Work Order ID 86199

DART SERVICE INSTRUCTION

TO AMEND INSTALLATION INSTRUCTIONS D350-591 REV. G
AND INSTRUCTIONS FOR CONTINUED AIRWORTHINESS ICA-D350-591 REV. 3
REF TCCA STC: SH92-6
REF FAA STC: SH967NE

TO PROVIDE AN OPTIONAL CUSHION KIT TO BE INSTALLED ON THE D350-591-111A/-113/-115/-117A/-119 *Heli-Access-Step™* (THE D2856-400-720 ABRASION STRIP IS REPLACED WITH THE D3595-200-300 CUSHION).

FIGURE 32-9: Crosstube Attachment
REF ICA-D350-591

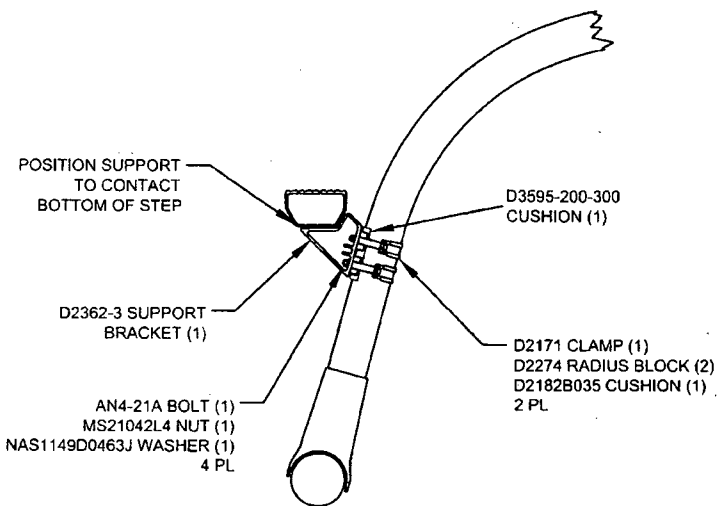
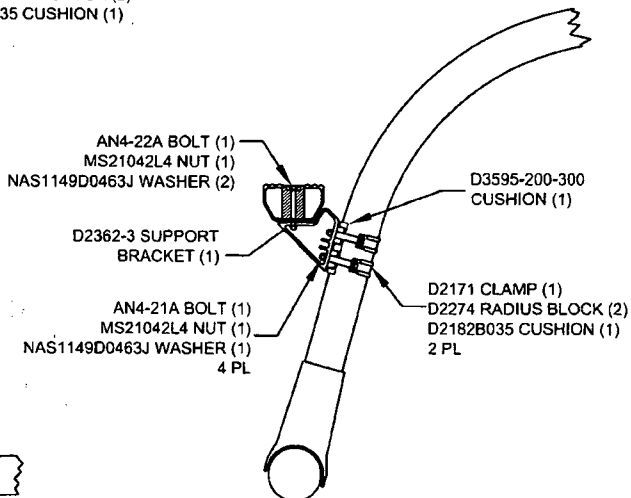
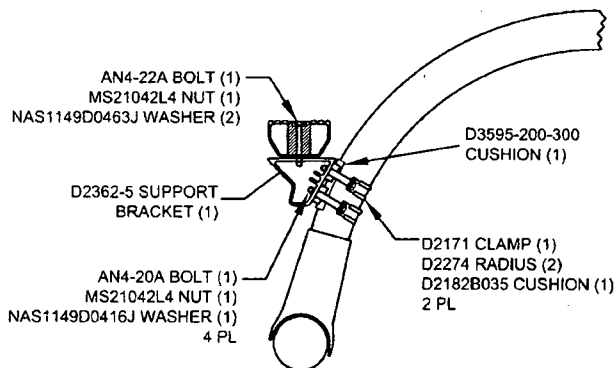
1. REMOVE THE STEP PER ICA-D350-591 SECTION 32.2
2. REMOVE THE D2856-400-720 ABRASION STRIP PER ICA-D350-591 SECTION 32.4
3. POSITION THE D3595-200-300 CUSHION AS INDICATED ON SHEET 3 OR 4 (AS APPLICABLE) OF THIS SERVICE INSTRUCTION.
4. REINSTALL THE STEP PER ICA-D350-591 SECTION 32.1 AS APPLICABLE USING THE NEW HARDWARE PROVIDED AS SHOWN ON SHEET 3 OR 4 (AS APPLICABLE) OF THIS SERVICE INSTRUCTION.
